AISC TALL BUILDING STUDY COMMITTEE

FINAL RECOMMENDED ACTIONS

April 1982

Fritz Engineering Laboratory Report No. 440.11

ALLOWABLE STRESS vs LOAD 250 UB 37 SECTION $F_y = 250$ MPA

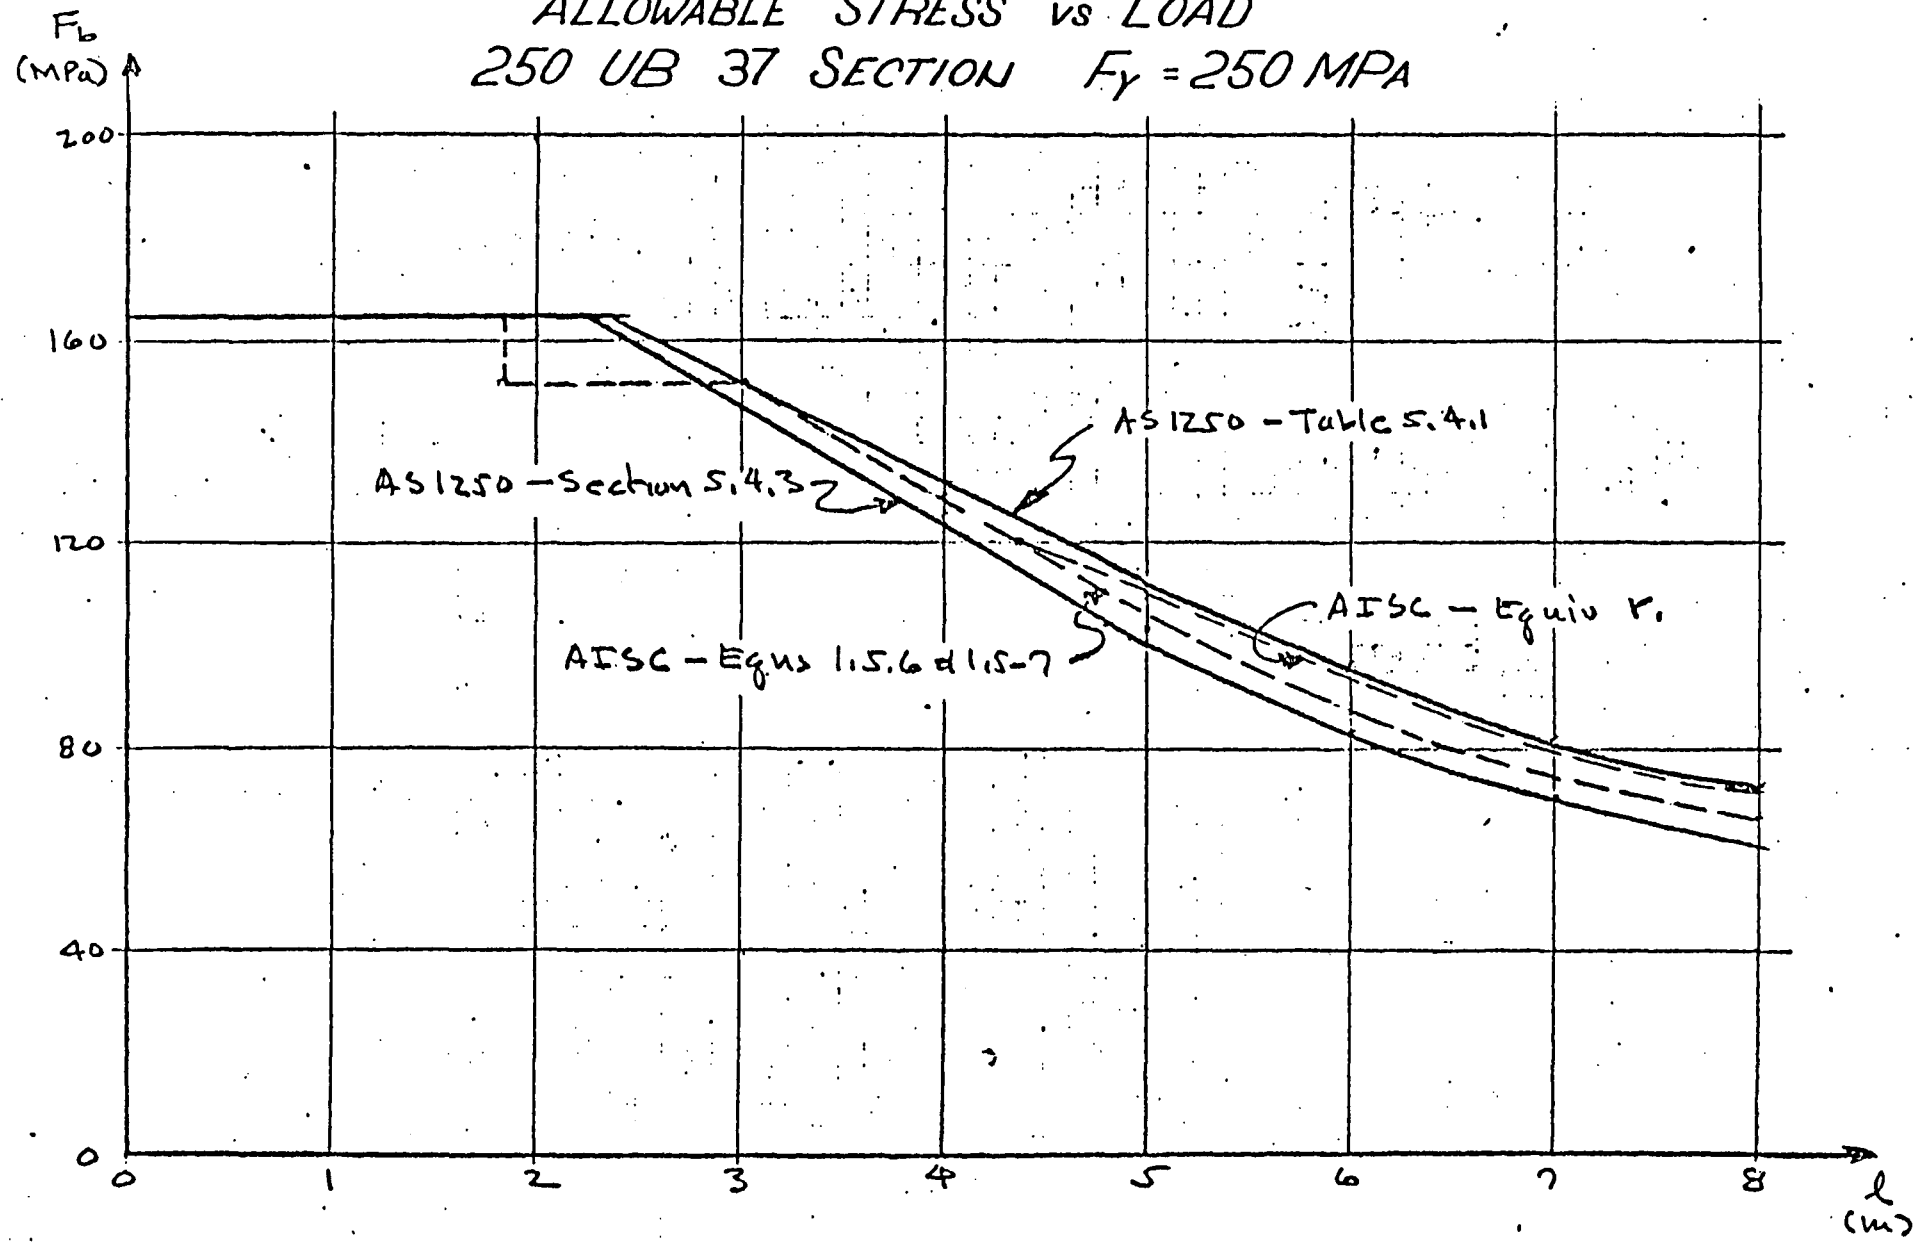
Suggested Addition to Specification, (McGuire 4Sep79):

Consideration should be given to a lateral buckling provision such as that appearing in the Australian Code, AS 1250 (Standards Association of Australia, 1975).

Background Information: Section 5.4.3 of AS 1250 (see p. 13) is appealing in its approach, in that it gives one a mechanism for using an elastic flexural-torsional buckling solution in design if one chooses to do so. For those who do not so choose, a simple formula for F_{ob} is also given in the Specification (not enclosed). I would think that, in most cases, the simple formula would be used. But for many of the more complicated loading and boundary conditions that often arise, a designer could find and use a corresponding elastic solution for F_{ob} .

I haven't made a systematic comparison of the numerical results to be obtained under AISC and AS 1250. In one example I found similar result (see p. 14). If it is decided to pursue this suggestion, I would recommend that a small research project be set up in which a Master's student could make such a systematic comparison. If the outcome of the study is that the Australian formulas yield reasonable results in standard cases, then serious consideration should be given to incorporating them in the AISC Specification.

McGuire (22Oct80): Perhaps I should stress that the recommended change appeals to me because of its versatility and not because it represents any improvement over the present AISC Spec in its application to simple situations.

Foreman (6Nov80): Since this suggestion requires further research and study, I feel that at this time it should not be recommended to the Main Committee for inclusion in the specification. We could, however, bring this need for further investigation to the attention of the Main Committee.

Munse(24Dec80): This needs to be discussed thoroughly by the committee.

RECOMMENDED ACTION: CBS Refer the matter to SSRG.

Item 1.18.2 (Specification)

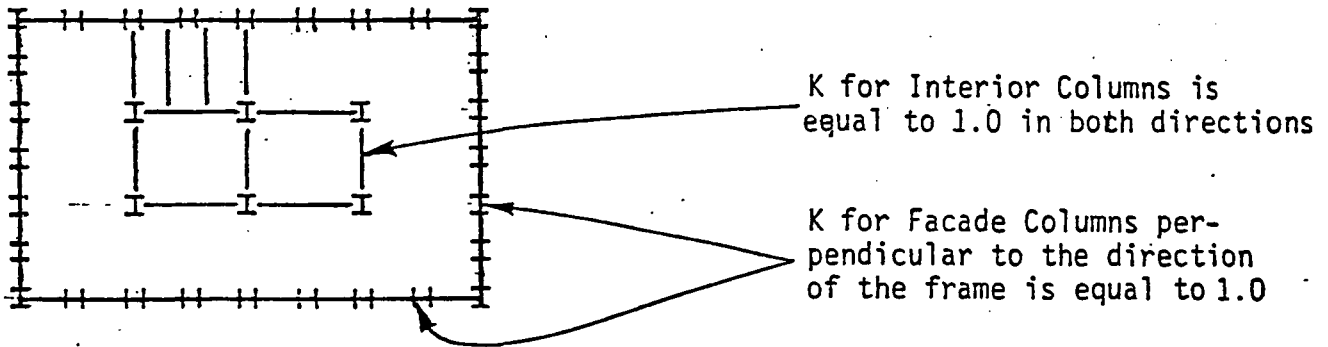
The effect of braced frames or shear walls in laterally restraining other columns is recognized in this section.

Similar conditions exist for other types of systems, such as the composite tubular system, and various forms of framed tubes, as shown below.

Suggested Addition to Specification, (Iyengar)

Fig. C2.4.1 Typical maximum strength interaction surface for particular column of known length subject to biaxial bending

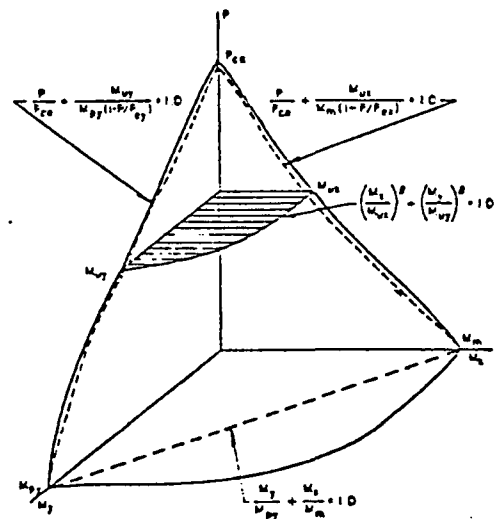
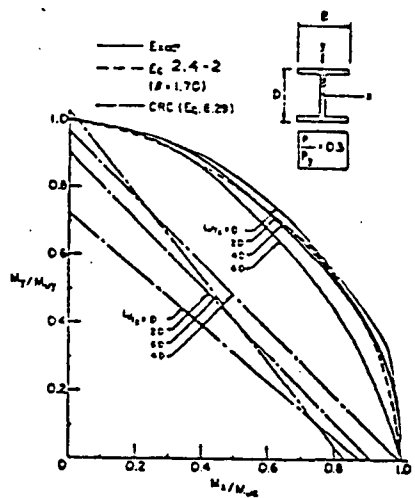
If the solid lines on the mutually perpendicular planes of Fig. C2.4.1 represent the actual failure curves under the relevant restricted loading conditions, then the dotted lines represent the existing design requirements. In particular, the straight-line interaction of biaxial moment for a given axial load corresponds to the current AISC design expressions (AISC, ~~1969~~), as well as CRC Eq. 6.19 of the second edition of the CRC Guide to Design Criteria for Metal Compression Members (Johnston, 1966) and to SSRC Eq. 8.29 of the Guide to Stability Design Criteria for Metal Structures (Structural Stability Research Council, 1976). Recent research has shown that the interaction of moments about the orthogonal axes is not linear (Tebedge and Chen, 1974). On the contrary, the interaction curve resembles more closely the quadrant of a circle (see Fig. C2.4.2). It is important to note that if a member is fully loaded under axial load and bending about one axis, then there is no spare capacity to accept moment about the other axis. However, as the loading decreases slightly below the maximum, capacity rapidly develops to accept bending about the other axis.

Extensive comparisons have also been made with the results of tests on actual columns, providing final confirmation of the validity of the interaction formulas (Springfield and Hegan, 1973). Springfield's evaluation of Chen's interaction equation (Eq. 2.4-2) showed that, for Birnstiel's tests, Eq. 2.4-2 was quite reliable [Mean 1.01, Standard Deviation 0.074]. A further verification of Chen's equation is its good agreement with Birnstiel's incremental analytical procedure (Birnstiel and Michalos, 1963). Aside from one result, in which the error was 7% conservative, all the other values agree to within 3%. (Council on Tall Buildings, 1979, pp. 254-257).

Fig. 6.63 Possible modification of corner joint to reduce risk of tearing

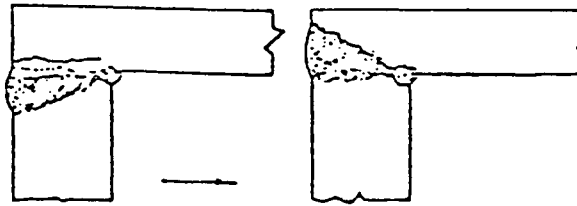
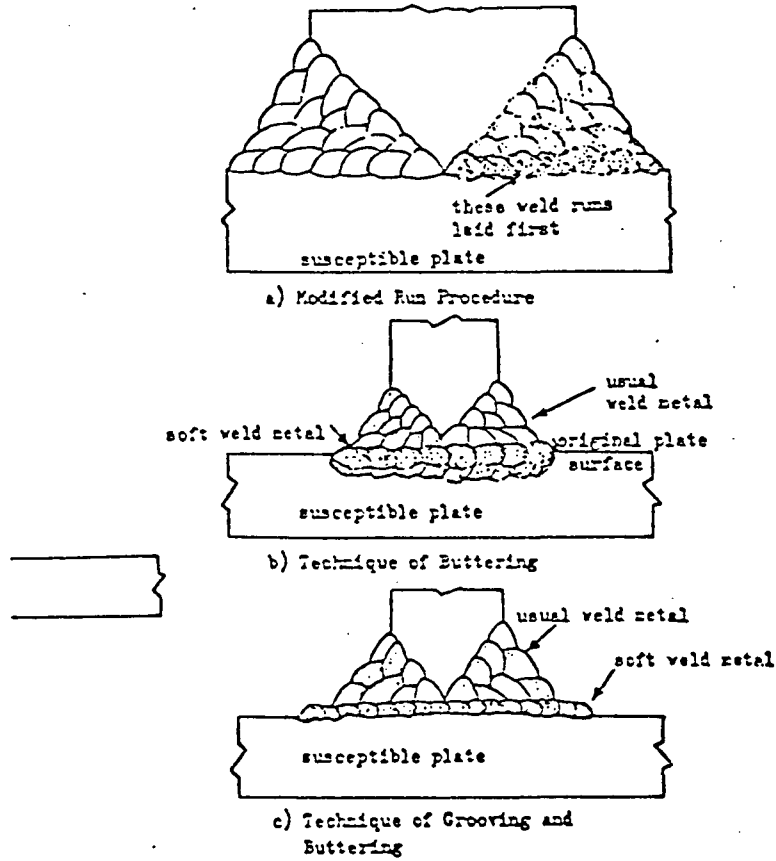
Design. Lamellar tearing generally results when a high degree of restraint is built into a weldment and produces large strains in the through-thickness direction of rolled steel plates or shapes. Therefore, care must be exercised in design to provide flexibility that will relieve the strains that might develop as a result of weld shrinkage, particularly in a highly restrained weldment. In addition, the welding processes and procedures should be selected so as to reduce to a minimum the susceptibility of a weldment to lamellar tearing.

Recommendations. Farrar et al. (1969) made suggestions for reducing the risk of lamellar tearing, which involve decohesion at inclusions or inclusion clusters, followed by linkage of the decohesed regions by shear or by normal ductile fracture for smaller inclusions. To reduce the risk of lamellar tearing of a corner joint, they propose the redesign shown in Fig. 6.63, because the fusion boundary is no longer parallel to the plane of the plate. Some other remedial measures that can be taken to reduce the risk of lamellar tearing are shown in Fig. 6.64. They are: (1) The use of low-strength weld metals; (2) modified run procedure; (3) buttering; and (4) balanced welding (Farrar et al., 1969). Further recommendations can be found in a commentary prepared by the American Institute of Steel Construction (AISC, 1973).

Heuschkel (1971) showed that decohesion cracking parallel to the plate surfaces occurred most commonly in corner and tee joints when welded under conditions of high restraint, whereas minimum weldment susceptibility to decohesion cracking occurred in clean, ductile, tough steels, and where the designs and welding procedures involved minimum rigidity and the lowest residual stresses. (Council on Tall Buildings, 1979, p. 452).

RECOMMENDED ACTION: Refer the matter to CBS for a possible appointment of study committee.
